February 4, 1998

Subject: American Zinc, Lead, and Smelting Company Site, Caney, Kansas

**PROPOSED STOCKPILE,
AMERICAN ZINC, LEAD, AND SMELTING CO. SITE, CANEY, KANSAS**

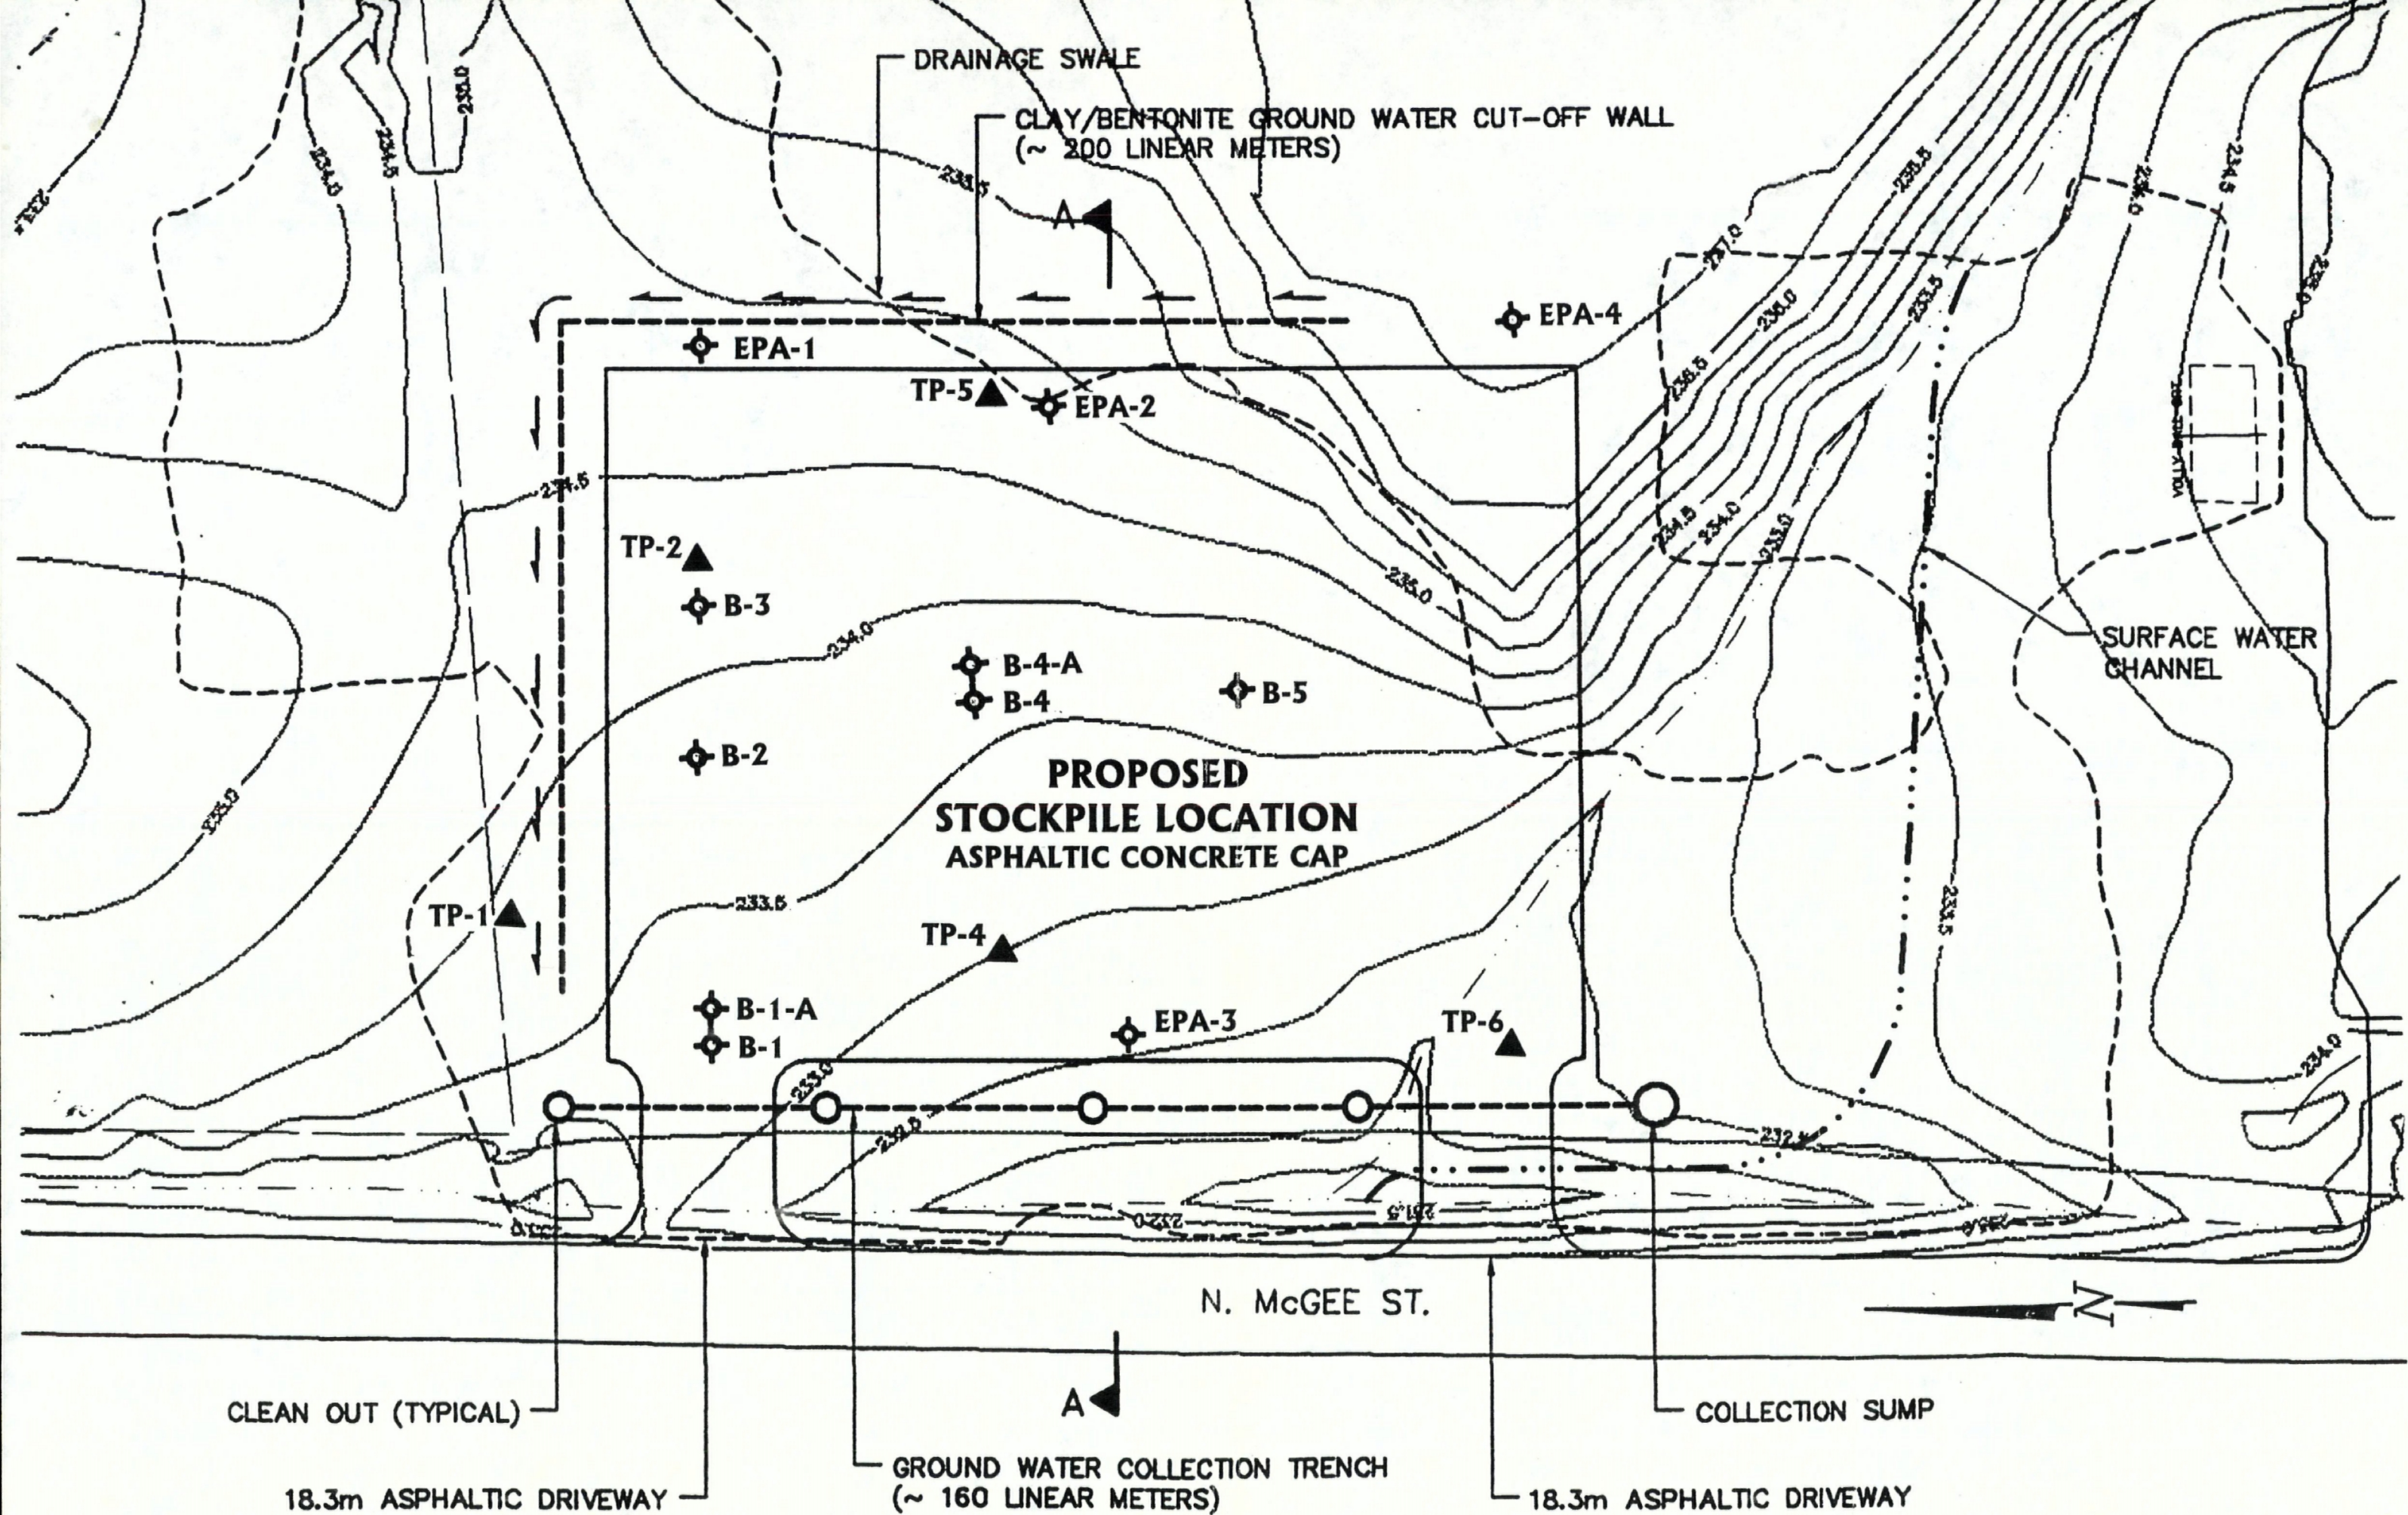
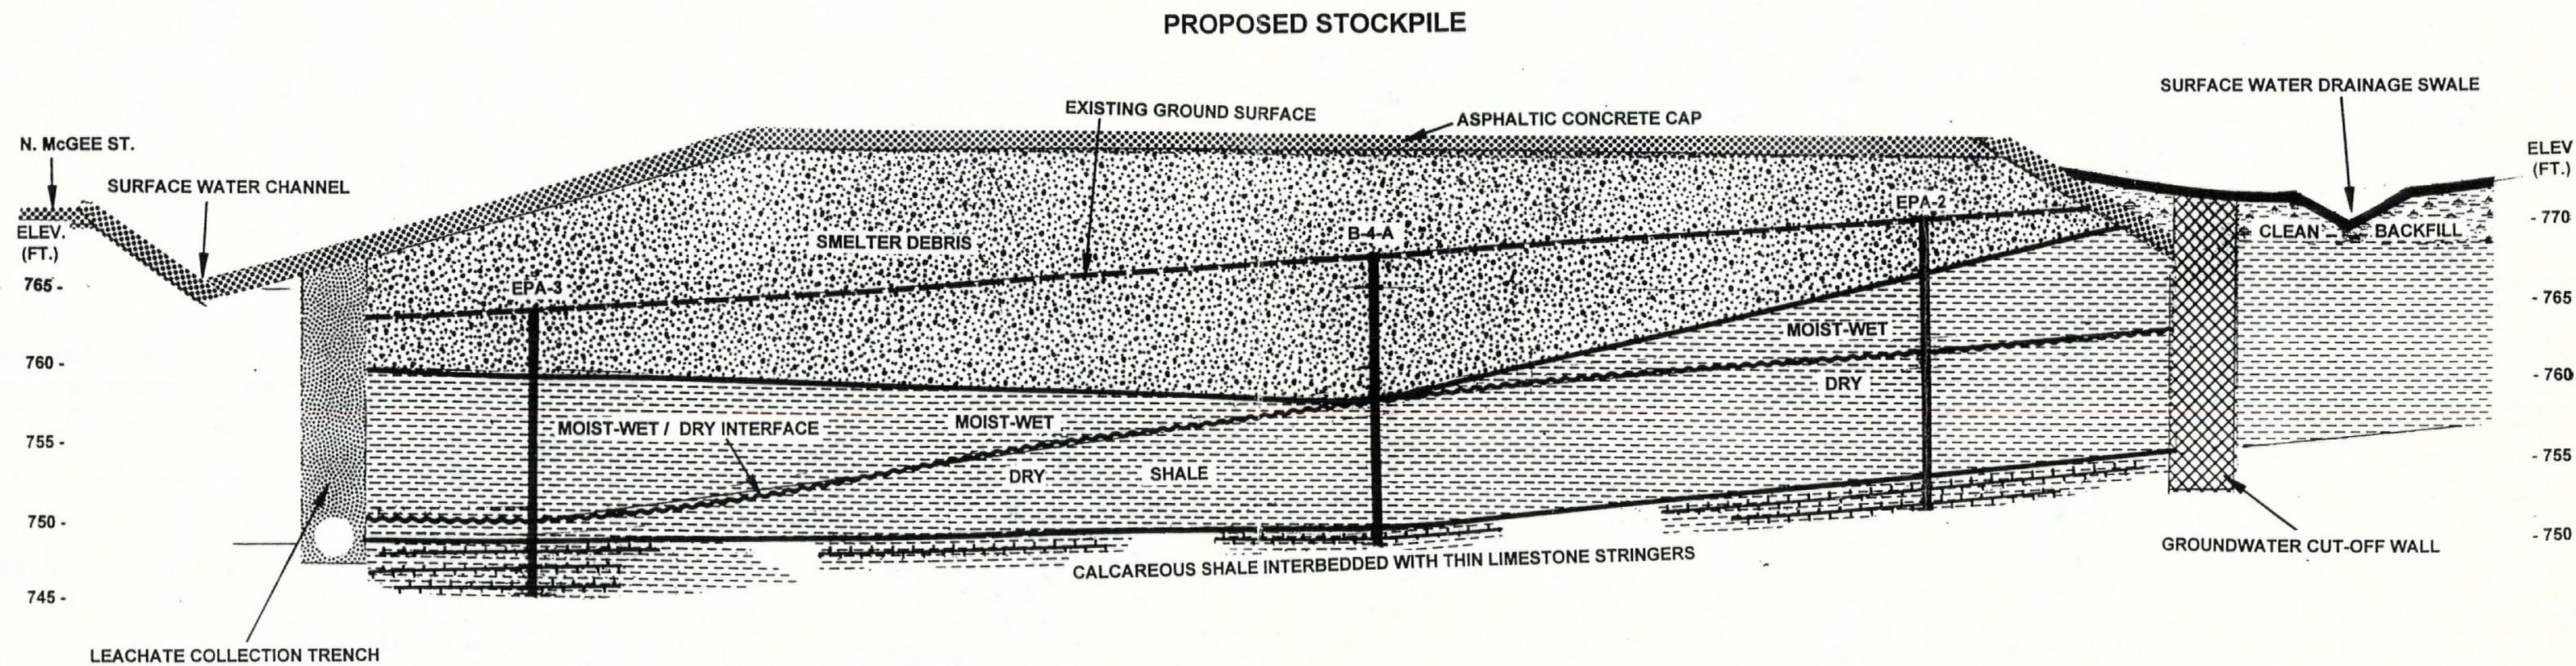
Please find enclosed the following: (1) a map showing the locations of boreholes and test pits completed to date by Dames & Moore and USEPA; and (2) a revised schematic cross section of the proposed cut-off wall barrier, stockpile, and leachate collection system, based on borehole data collected by USEPA on January 26-27, 1998.

The validity of the borehole and test pit data presented by Dames & Moore in a Geotechnical Investigation Report (December 12, 1997) and used to develop the schematic cross section in the EE/CA (Figure D-2), has been questioned by both USEPA and KDHE. In response, on January 26th and 27th, 1998, USEPA drilled six (6) boreholes in the area of the proposed stockpile to determine the thickness of smelter waste and native lithologies beneath the smelter material. A limestone bed, identified by Dames & Moore as ranging from 7 to 12 feet below ground surface, was not found during the USEPA drilling. However, USEPA did identify calcareous shale and interbedded, thin limestone stringers at a depth ranging from 14.5 to 17.5 feet below ground surface in several of the boreholes. In response to these findings, KDHE proposes the following with regard to the design of the cut-off wall barrier and leachate collection trench.

1. Seat the base of the *Clay/Bentonite Groundwater Cut-Off Wall* in the upper one (1) foot of the calcareous shale and interbedded limestone stringer unit. This will ensure that a sufficient interval of native shale is present below the smelter material to prevent "wicking up" of groundwater by capillary action from below; and
2. Seat the base of the *Leachate Collection Trench* in the upper one (1) foot of the calcareous shale and interbedded limestone stringer unit. KDHE believes that any groundwater which might penetrate the asphaltic concrete cap and percolate through the smelter material and the underlying shale would, when reaching the calcareous shale and interbedded limestone stringer unit, migrate laterally and downgradient to the leachate

collection trench.

Physical characteristics of the calcareous shale and interbedded limestone stringer unit suggest that it is as impermeable or more impermeable than the overlying shale and thus would be a barrier to downward percolation of contaminated groundwater.
